PHILADELPHIA ELECTRIC COMPANY

Subject: Limerick Generating Station, Units 1 and 2
Core Performance Branch and Reactor Systems
Branch

As discussed in the reference telecon the information contained on the attached draft FSAR page changes will be incorporated into the FSAR, exactly as it appears on the attachments, in the revision scheduled for August, 1983.

FIGURE 15.4-1

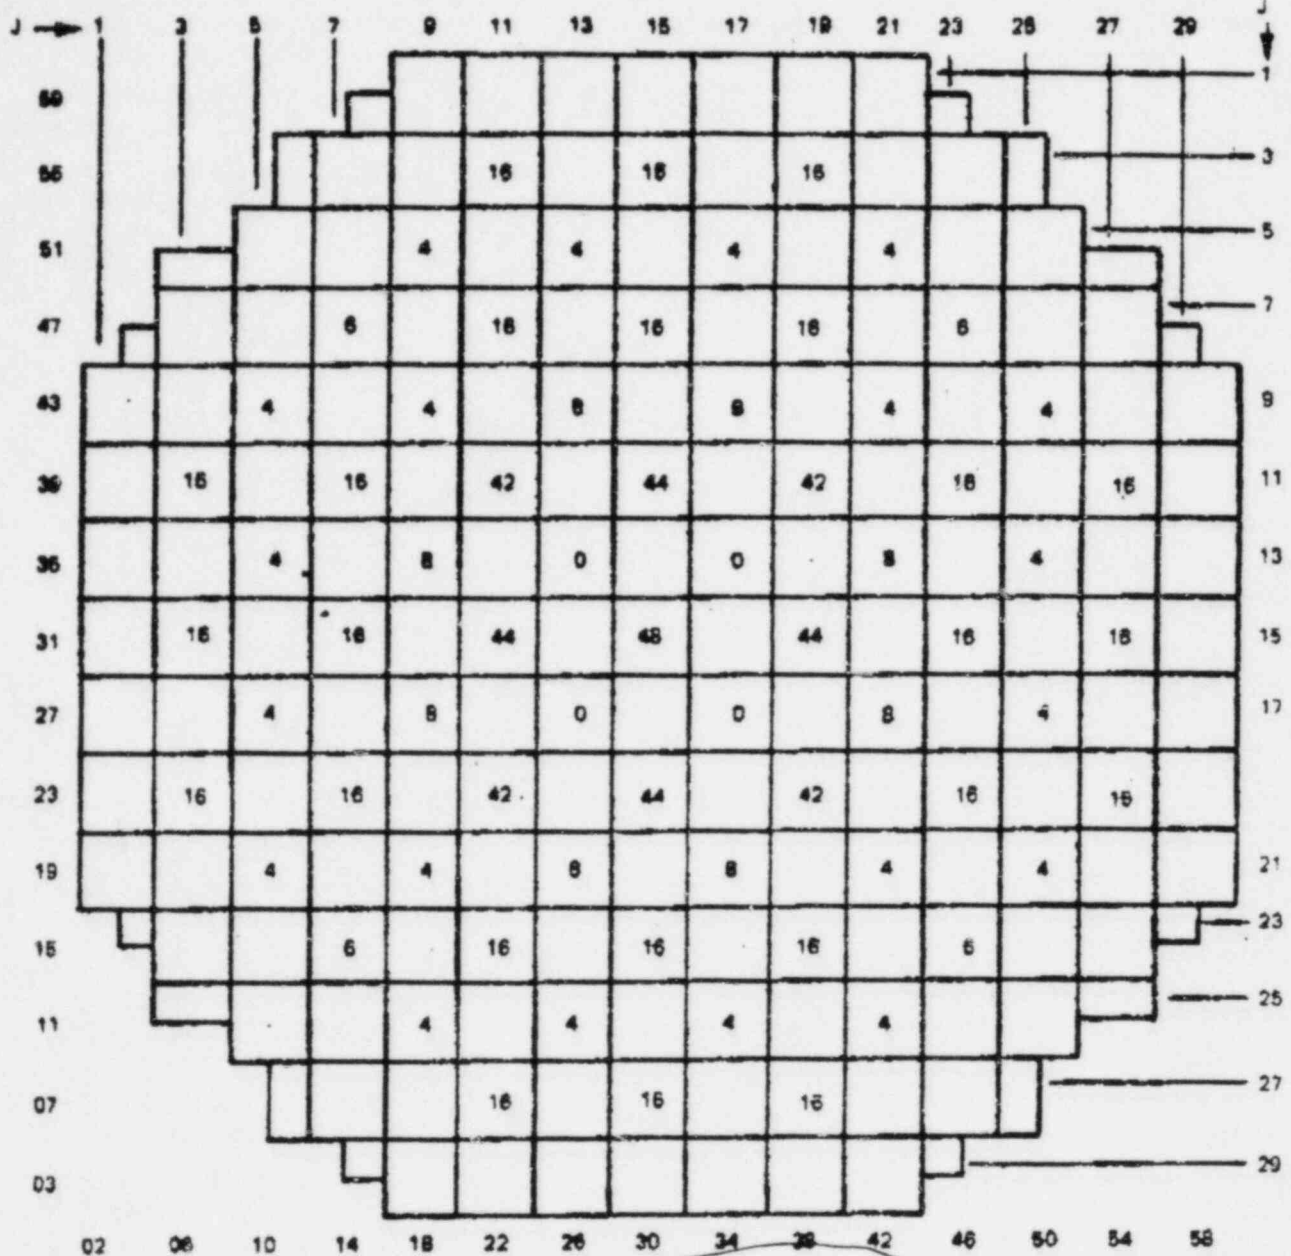
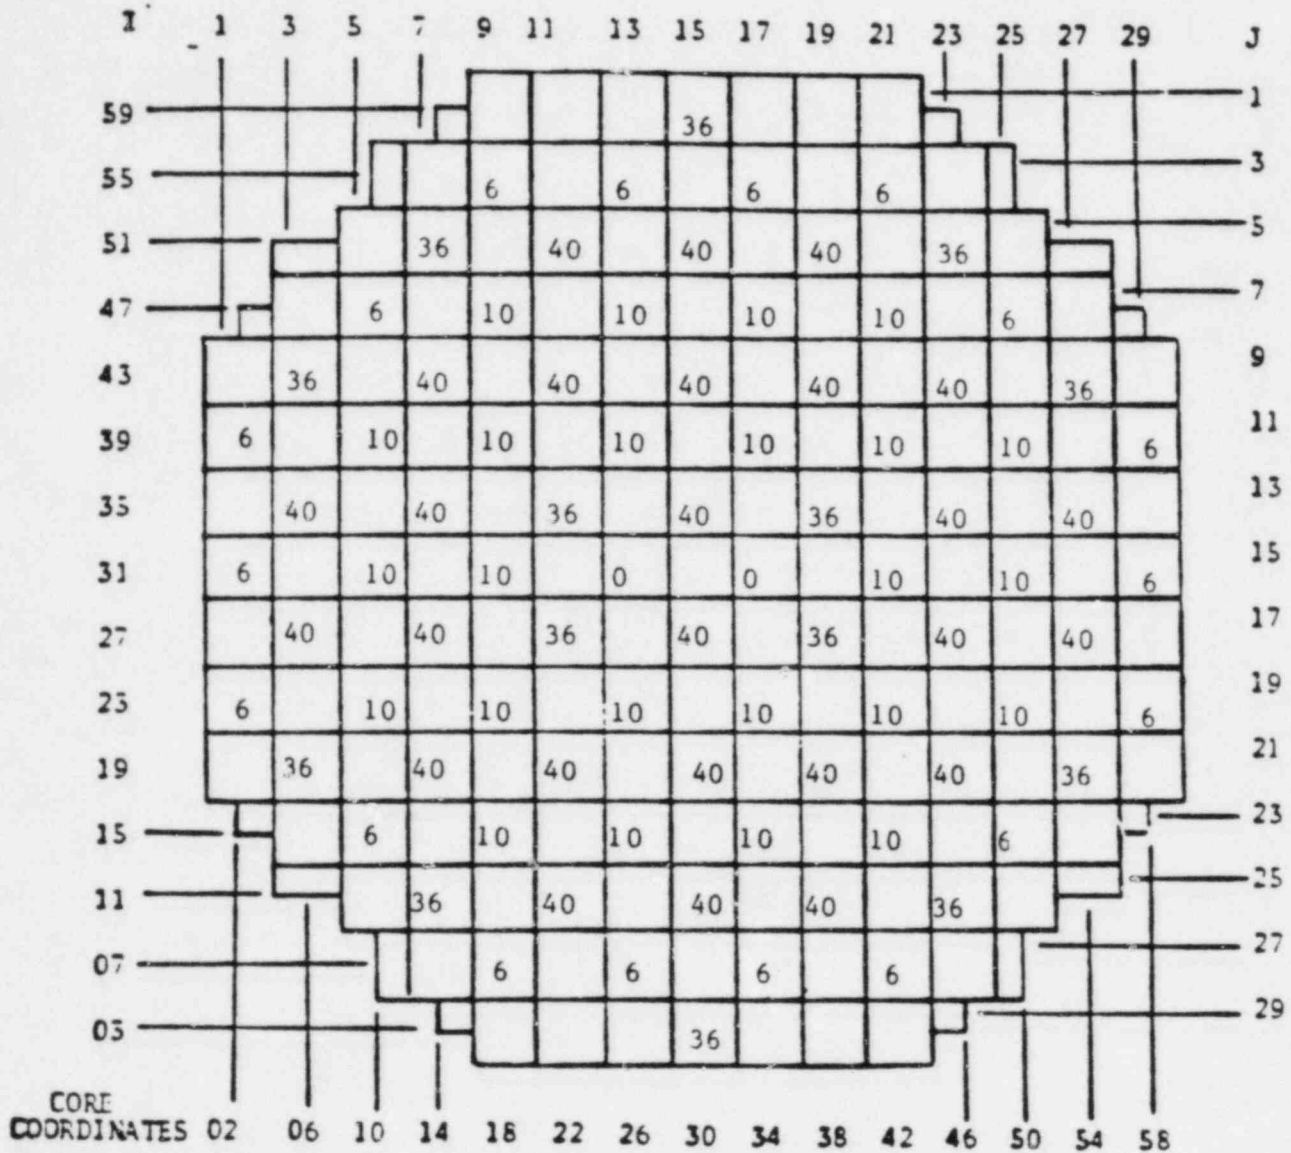
REPLACE THIS FIGURE
WITH FIG. 15.4-1
ATTACHED

"NEW FIGURE"

LIMITING CONTROL ROD PATTERN FOR ROD WITHDRAWAL ERROR

FIGURE 15.4.4

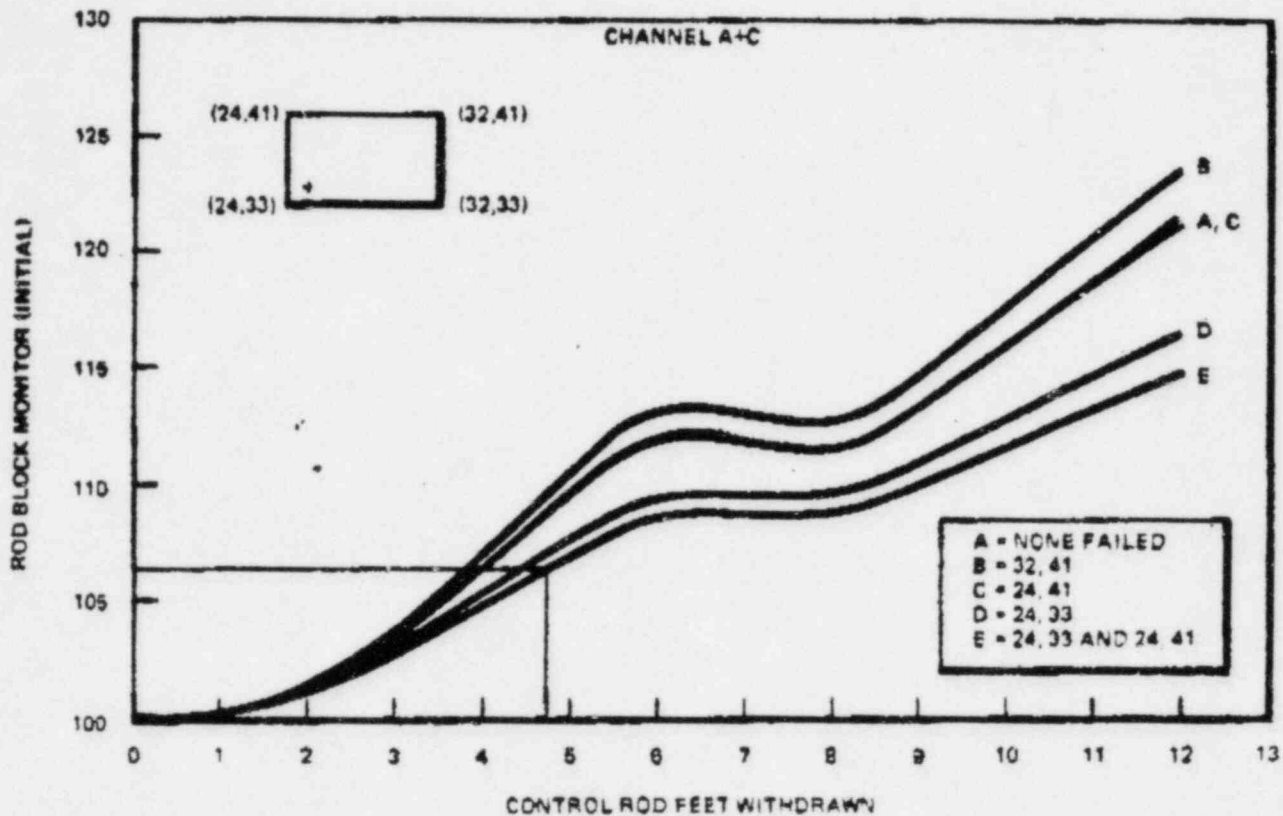
DELETE THIS
FIGURE

FIGURE 15.4.5

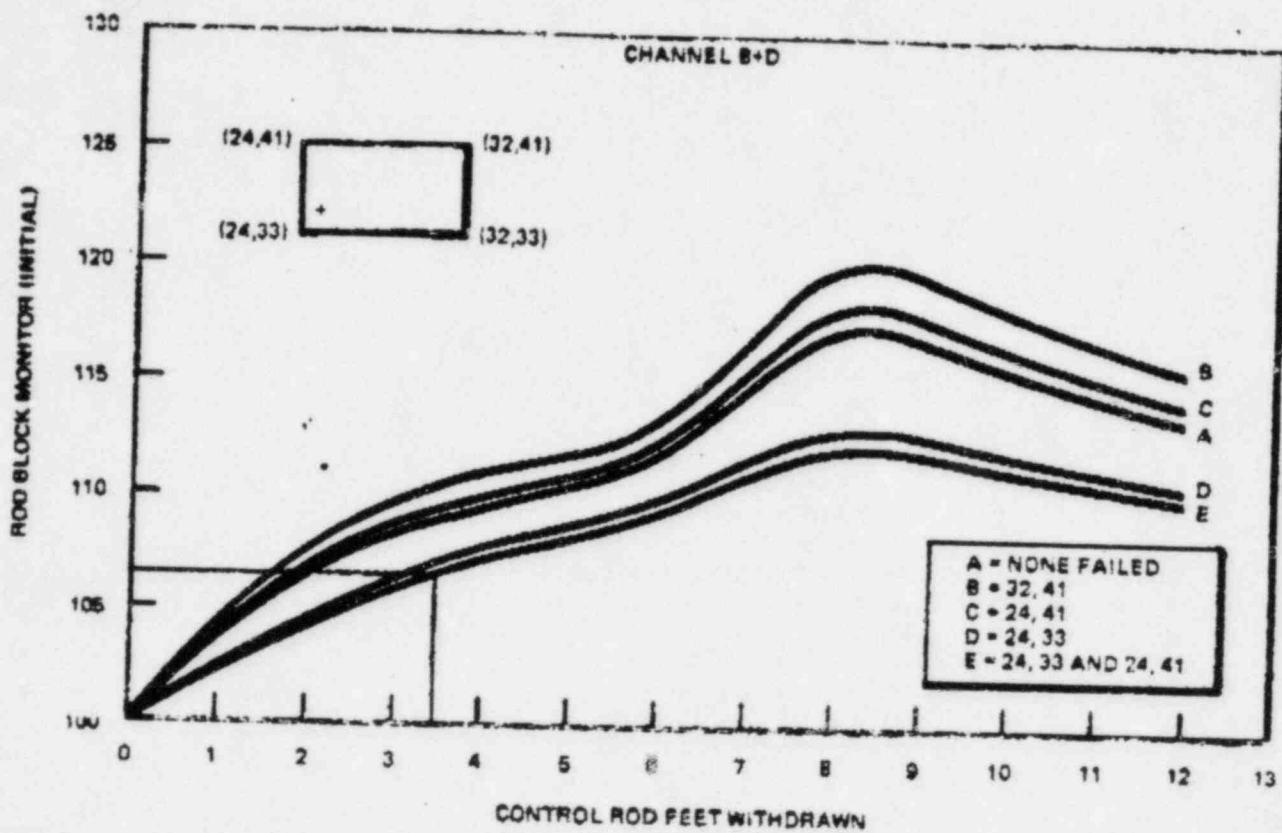
DELETE THIS
FIGURE

FIGURE 15.4-8

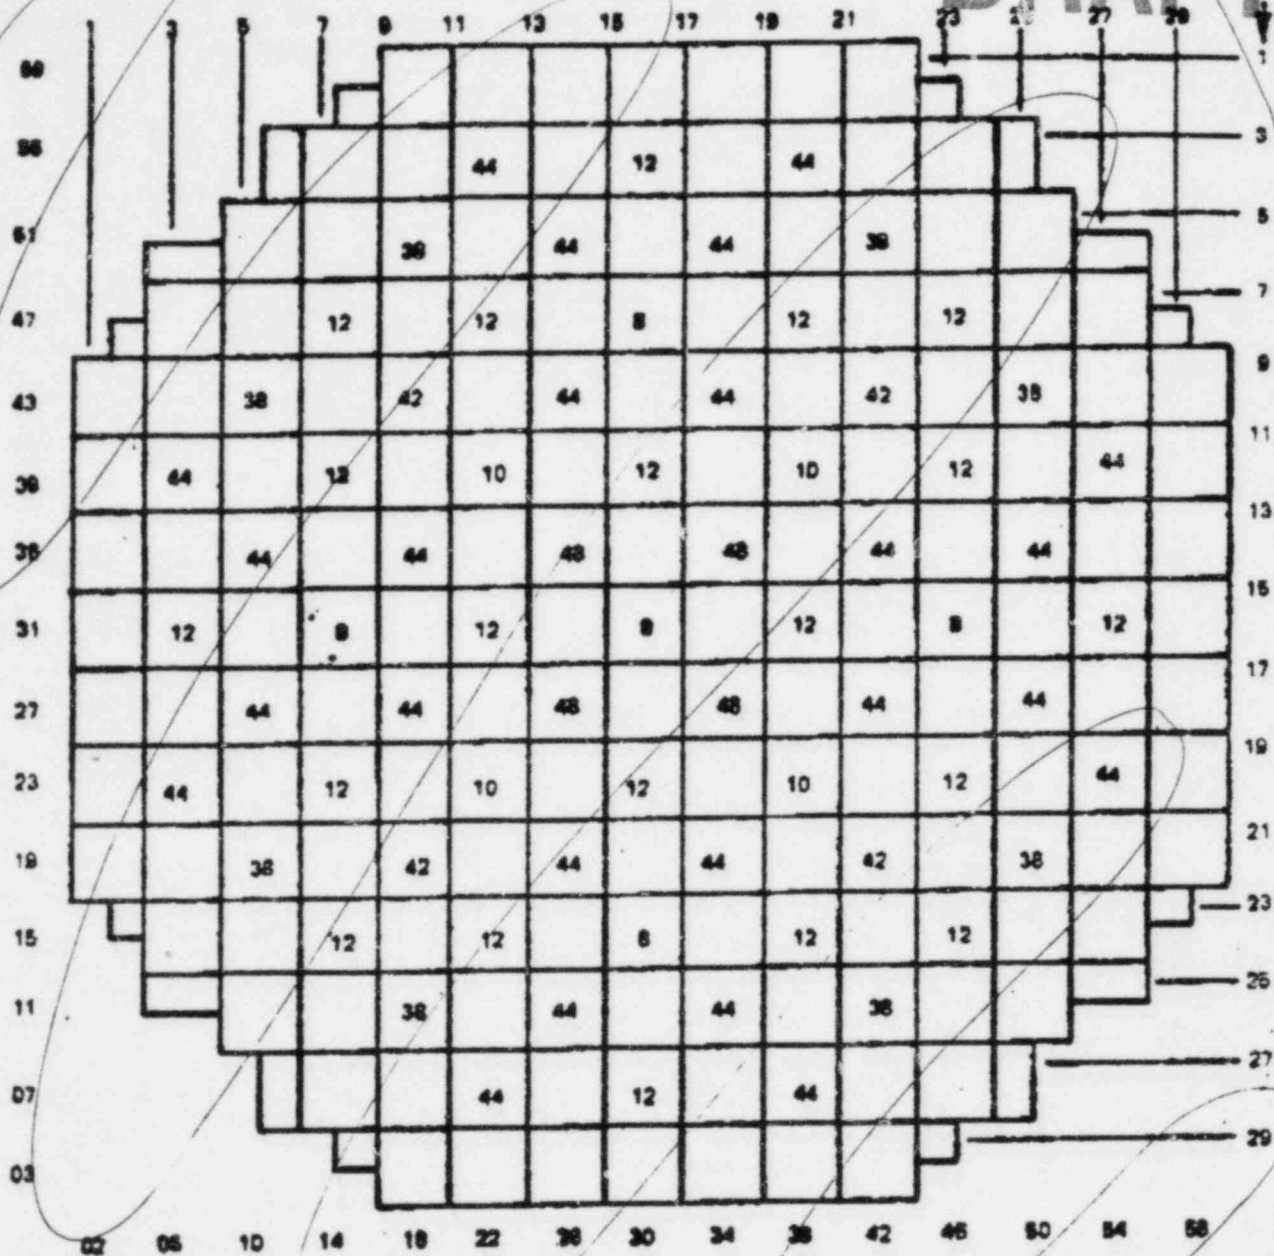
DELETE
THIS FIGURE
